U.S.S.N. 09/700,139  
Group Art Unit: 2644

### AMENDMENTS TO THE DRAWINGS

Fig. 4b

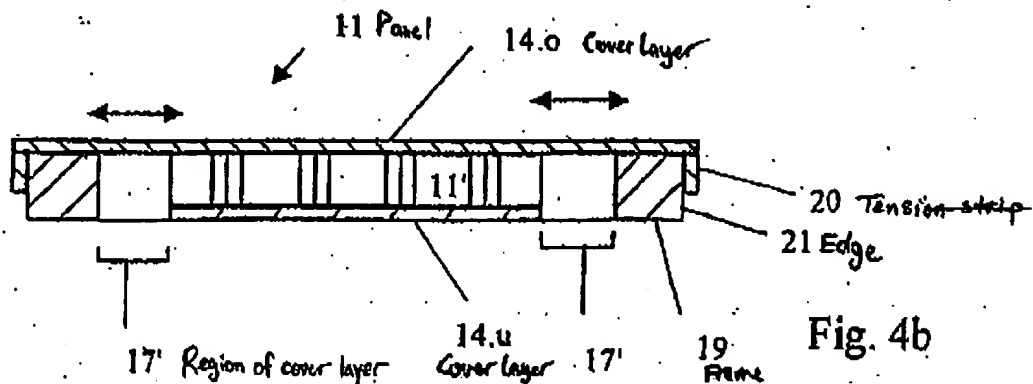
Figs. 4b and 5b are amended to indicate that reference number 17' refers to "Region of cover layer" rather than to "connecting element." Support for this amendment may be found, among other places, at page 8, line 11 and line 24 of the specification as filed.
